VMC/HMC - Programmable Coolant - Upgrade

This bulletin describes the field replacement of an old style pcool with a new pcool. Two basic kits are available; 93-1475 for the vertical mills and 93-1480 for the horizontal mills. As there are a number of items that need to be installed with the new pcool on a retrofit application, the corresponding hardware for each configuration machine is selected using the following table. In direct replacement of an existing new pcool, some of the below components (e.g. cable cover) may need to be installed to update the assembly (see Figure2.).

Figure 2. Typical installation of new Pcool without cable cover and coolant manifold

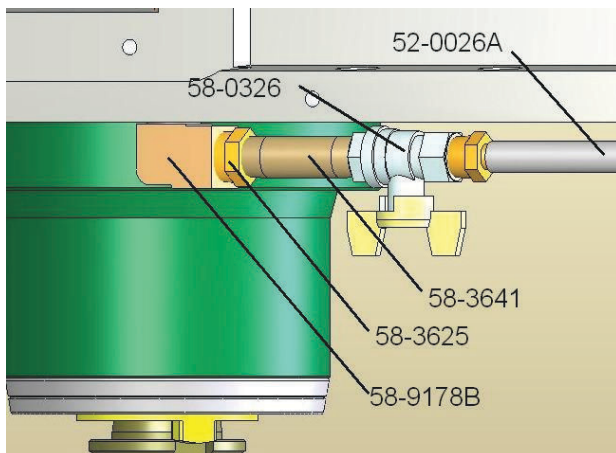
On early machines (such as VF-0) where a standard coolant manifold is not installed (see Figure 1.), other hardware will be required to adapt the new pcool to the spindle head (see Figures 2-4). The below list of hardware should be kept on hand to assure proper installation of the kits. The following items will be useful:

1. Install the cable into the spindle housing and route the cable up to the connector bracket.
2. Install the pcool hose at the 45° elbow. Apply thread sealant as needed.
3. Install cable cover between the mounting bracket and the spindle. Install screw and route the cable in the cable cover. Tighten mounting screws.
4. Verify that the nozzle sprays at the centerline of the spindle. Aim the nozzle by shifting the bracket horizontally on the spindle housing, then re-tightening the mounting screws.
5. Run a program to exercise the pcool with the coolant "ON" to verify operation.

Figure 7. Trim existing water supply tube per this sketch.

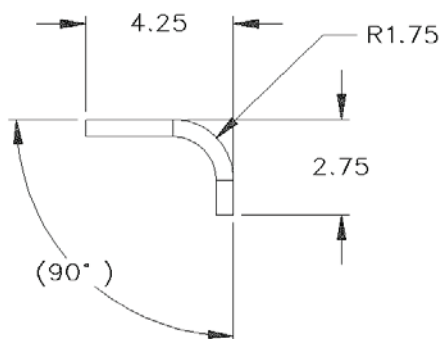
**This part can be made from 58-0789 (or 58-0788) by trimming the tube as per Figure 5.
